we, the undersigned, do object to the proposed amendment to Approved Licence 16-035 by the operator Solo Water at Catherine Hill Bay.

## Objection to Catherine Hill Bay-Network Operator **Variation**.

Currently Approved Licence 16\_035

Above is a photo of the lagoon April 2018

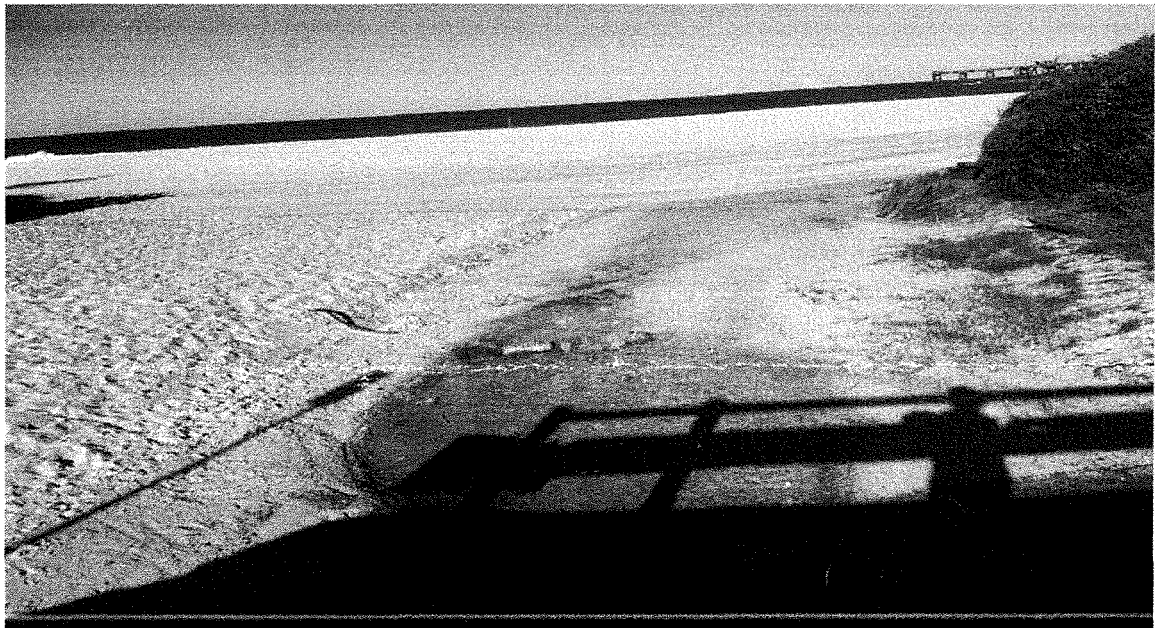
The assertion that “the excess water will flow through a coastal lagoon which has been estimated to be open to the ocean some 73% of the time is totally untrue. I live here, I see it every day. The lagoon has not opened once this year

How can they possibly say this when there has been no EIS. The original application did not address this issue as there was to be no discharge into the environment at all.
